CAA Environmental Assessment

Title of airspace change proposal	OSEP 11 (CLN)
Change sponsor	NATS
Project reference	ACP-2021-061
Account Manager	[REDACTED]
Case study commencement date	8 October 24
Case study report as at	11 November 2024
<p><i>Instructions</i></p> <p>In providing a response for each question, please ensure that the 'status' column is completed using the following options:</p> <ul style="list-style-type: none"> • YES • NO • PARTIALLY • N/A <p>To aid the SARG Lead it may be useful that each question is also highlighted accordingly to illustrate what is:</p> <p>resolved YES not resolved PARTIALLY not compliant NO</p>

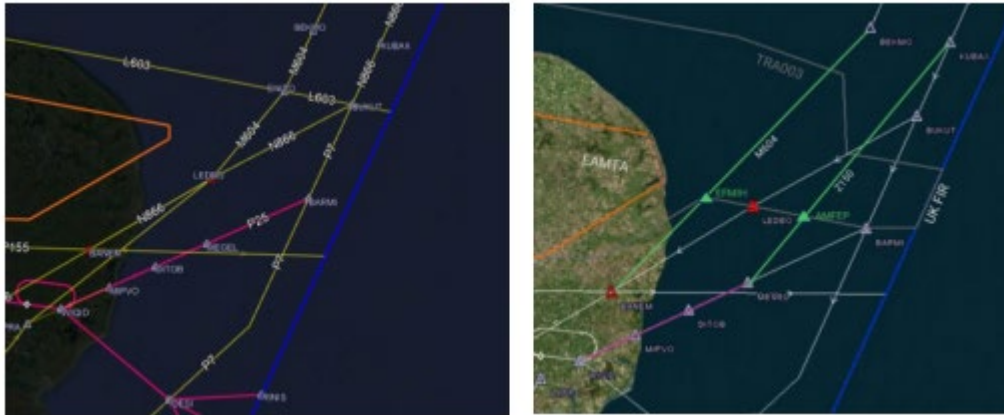
2. Nature of the Proposed Change		Status
2.1	Is it clear how the proposed change will operate, and therefore what the likely environmental impacts will be?	Partial
	<p>The ACP seeks to formalise revision of the lateral boundaries of the EAMTA in the UK AIP, facilitating the realignment of adjacent ATS routes to enable flight planable CO₂e benefits for affected traffic. The proposed published routes replicate current tactical flight behaviours when the extant EAMTA is not active. See comparison of existing and proposed routes below:</p> <p><i>Figure 1: Extant northbound route structure (left) and proposed northbound route structure (right).</i></p>  <p><i>Figure 2: Extant southbound route structure (left) and proposed southbound route structure (right).</i></p>

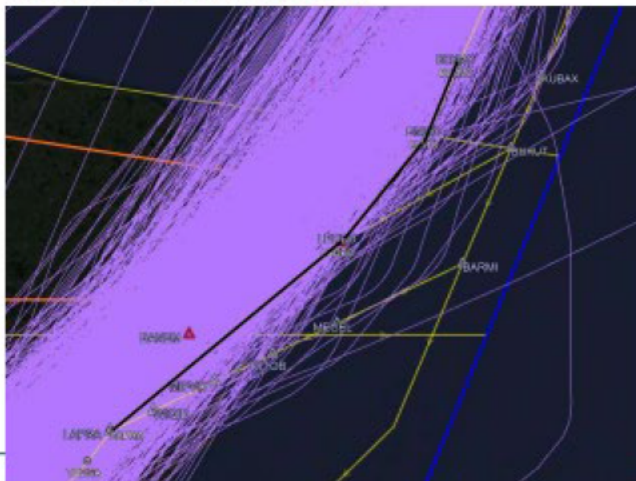
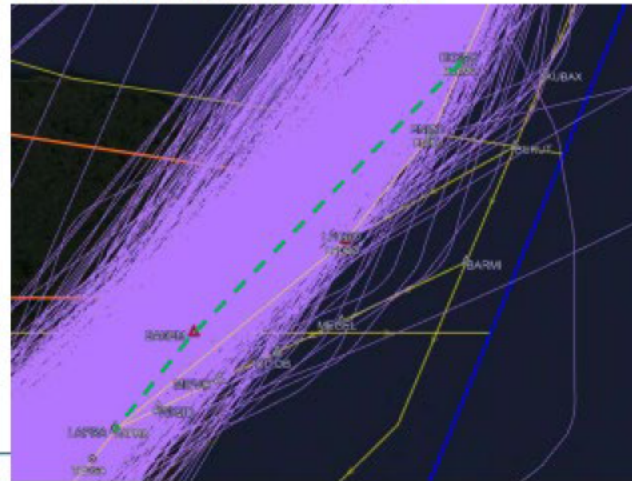
The predicted CO_{2e} emissions have been calculated based on the reduction in track mileage comparing the current and proposed published routes. However, flight planned data does not capture all the lateral variation in tracks which may include shortcuts or track extensions. As the ACP proposes that the proposed published routes are based on replication of current tactical flight behaviours, it is likely that the anticipated reduction in CO_{2e} emissions may be overstated.

The following proposed route diagrams (presented in the ACP) illustrate the reason why calculated CO_{2e} emissions are likely to have been over-estimated. The actual trajectories flown (purple lines) more closely replicate the proposed new routing than the current published routes which have been used to calculate the difference in track miles. Comparison of the actual trajectories and proposed routings would indicate less difference in track miles and a resultant smaller change in CO_{2e} emissions. Evaluation of the change in 'actual' track mileage and CO_{2e} emissions will be required through provision and analysis of pre and post ACP implementation flight trajectory data as part of the Stage 7 Post Implementation Review, if approved.

Implementation Review (if approved)? If yes, please list them below.	
	<p>Yes, the sponsor must collect the following data and perform the subsequent analysis for the PIR:</p> <ul style="list-style-type: none"> • The sponsor must use actual traffic movement numbers and trajectory data to calculate actual track mileage and CO₂e emissions for the first year of implementation of the ACP. • The sponsor must use actual traffic movement numbers and flight-planned trajectory data to calculate flight planned track mileage and CO₂e emissions for the first year of implementation of the ACP. • The sponsor must provide full details of the methodology and assumptions used to calculate track mileage and CO₂e emissions for the actual and planned calculations.
